FACILITY: AP600

SUBJECT: SUMMARY OF JANUARY 21, AND 22, 1997, MEETING WITH WESTINGHOUSE TO
DISCUSS THE AP600 PROBABILISTIC RISK ASSESSMENT (PRA) INSIGHTS

IMPORTANT PRA ASSUMPTIONS AND SAFETY INSIGHTS

STEAM GENERATOR TUBE RUPTURE

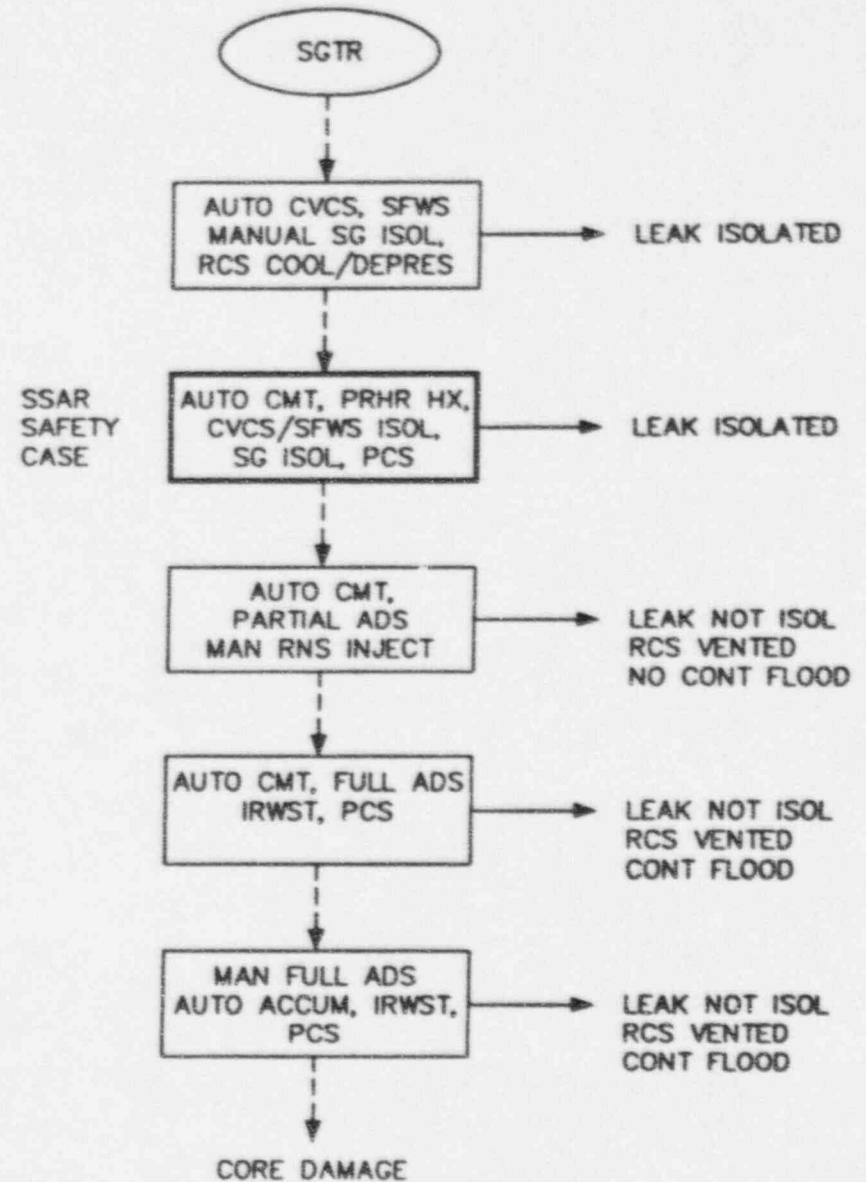
1. SIZE OF BREAK ASSUMED
2. T-H ANALYSES SUPPORTING ASSUMPTIONS AND SUCCESS CRITERIA
3. USE OF CVCS FOR INVENTORY CONTROL
4. MODELING OF SCENARIOS WITH RCP FAILURE TO TRIP
5. MODELING OF UNISOLABLE PATHS TO THE ATMOSPHERE
6. ASSUMPTIONS AND FAULT TREE MODELING OF THE TBVs
